Agenda
Village of Arlington Heights
Design Commission
Community Room, 3rd Floor

Arlington Heights Village Hall
33 S. Arlington Heights Road
Arlington Heights, IL 60005
May 22, 2018
6:30 PM

MINUTES OF
THE VILLAGE OF ARLINGTON HEIGHTS
DESIGN COMMISSION MEETING
HELD AT THE ARLINGTON HEIGHTS MUNICIPAL BUILDING
33 S. ARLINGTON HEIGHTS RD.
APRIL 24, 2018

PROPOSED DRIVEWAY PLAN

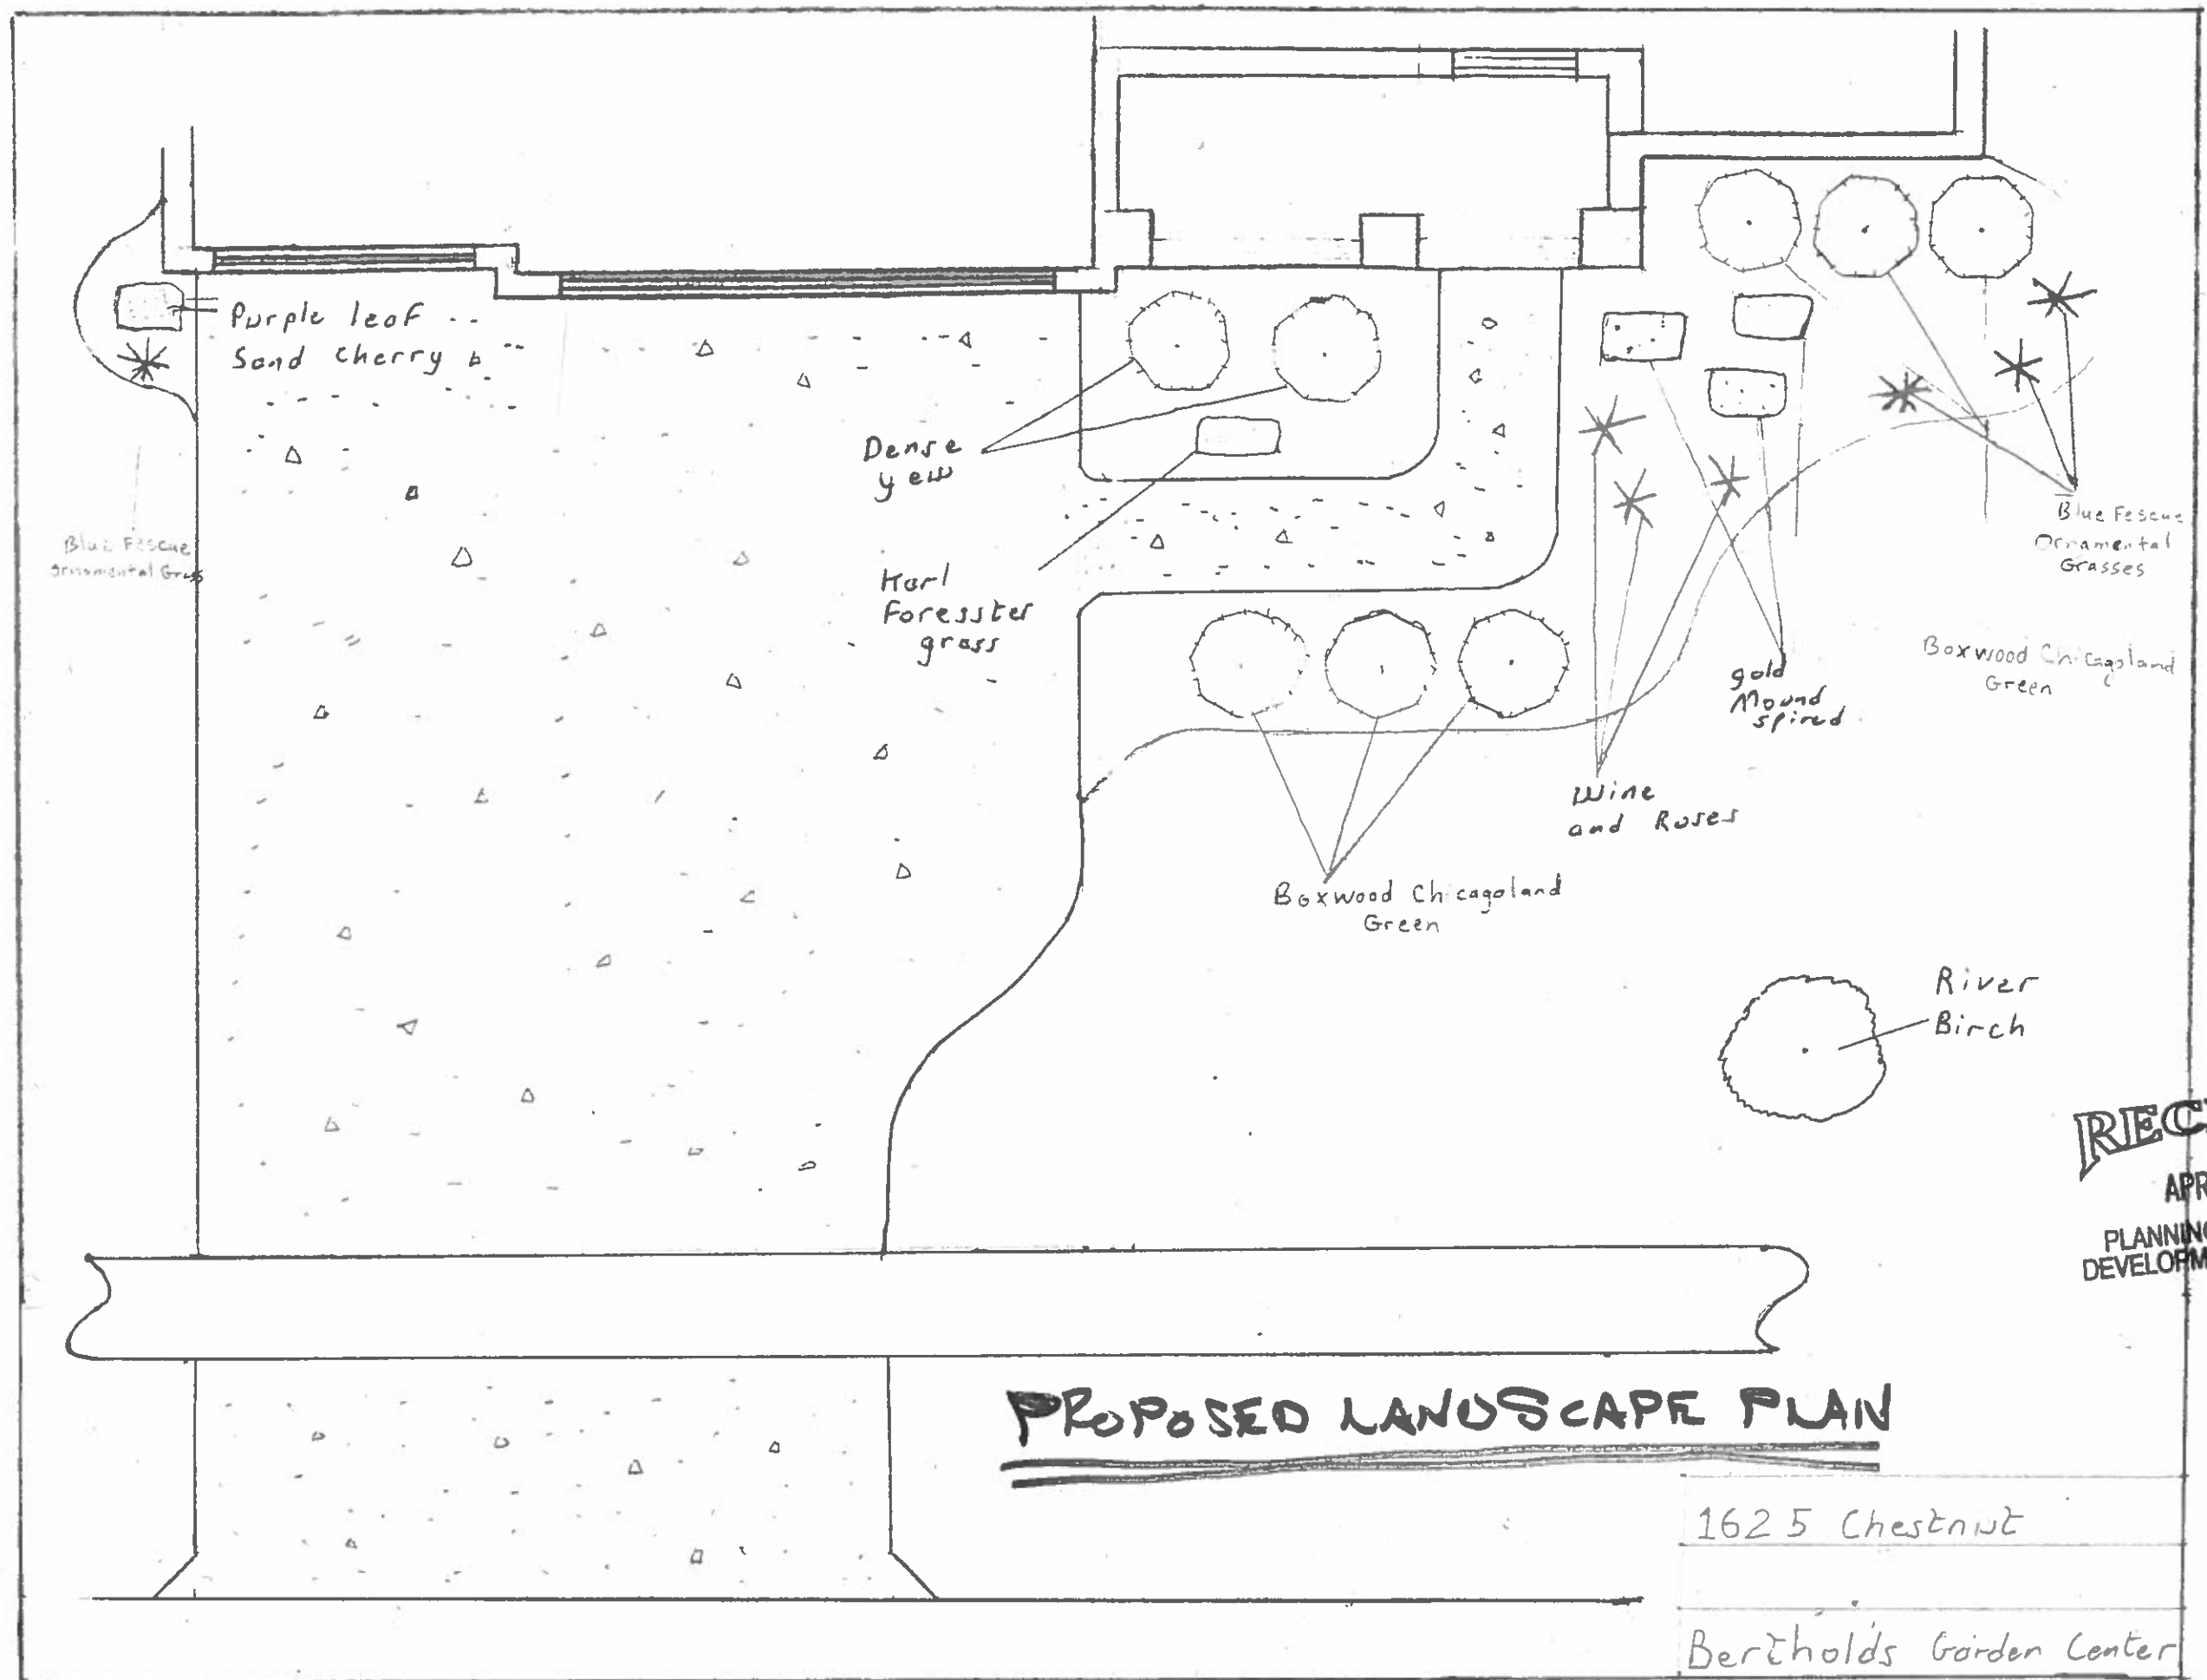
It is recommended that the Design Commission evaluate removing the previous condition requiring protection of the existing 22-inch parkway tree, associated with the approved new single-family residence located at 1625 N. Chestnut Avenue. This recommendation is based on compliance with the proposed driveway plan and landscape plan received on 4/17/18, and the following:

consider a Silver Maple to be a high quality type of tree, so they are not firmly opposed to removal and replacement with a higher quality tree at the petitioner's expense. The petitioner is also proposing to plant a new River Birch tree in the front yard of the property.

The lot is 88' wide and there is plenty of room to plant another tree. The builder has agreed to pay for the removal of the silver maple and plant a tree of substance in the parkway which would be more centered on the house and more visually appealing.
